CERTIFICATE OF APPROPRIATENESS

Property: 4104 Greeley St. Lot 5, Block 14, Lockhart Conner & Barziza

Significance: Contributing circa 1900 Queen Anne House

Proposal: Alteration – Work begun without a permit or a COA

Left Elevation (rear)

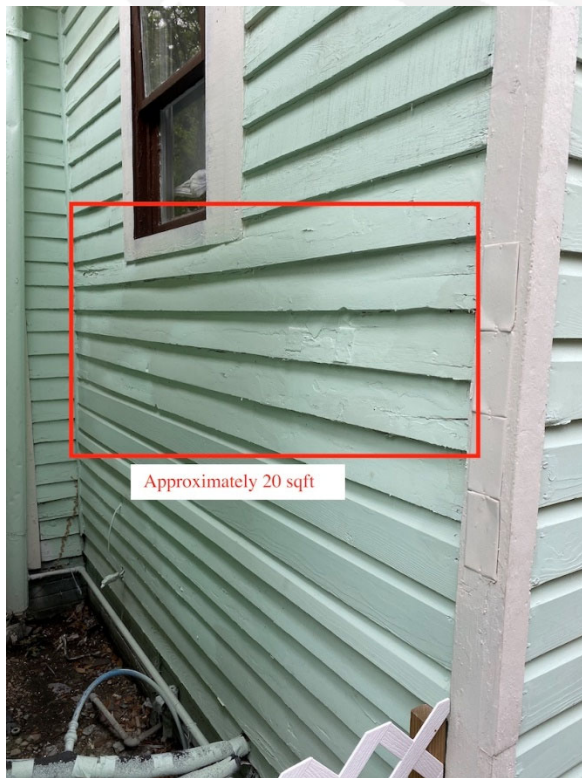
The wood siding in the specified area has been compromised by water damage.

The area around the window trim and sill has extensive rotten wood due to water damage.

We proposed to remove non-original wood and replace (splice where required) with (Cedar Bevel Siding 5/8"x6"x16' or approved material).

Rear Elevation

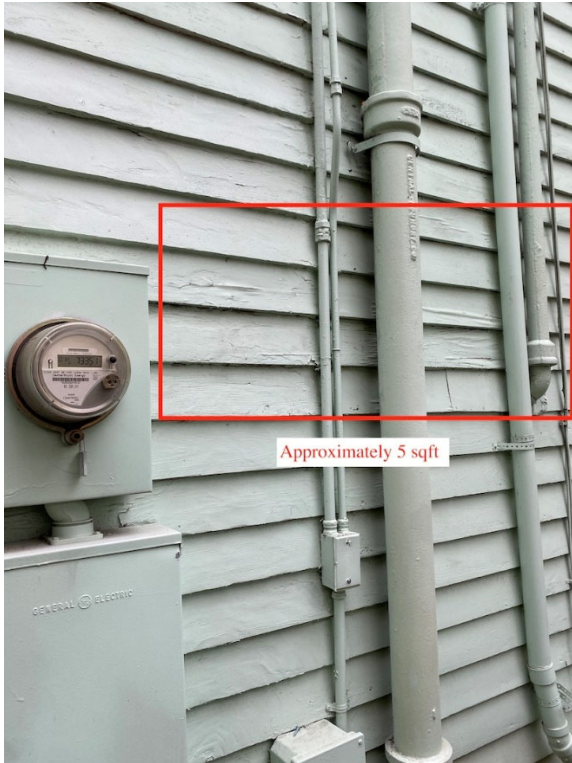
The wood siding in the specified area has been compromised by water damage.

The area around the window trim and sill has extensive rotten wood due to water damage.

We proposed to remove non-original wood and replace (splice where required) with (Cedar Bevel Siding 5/8"x6"x16' or approved material)
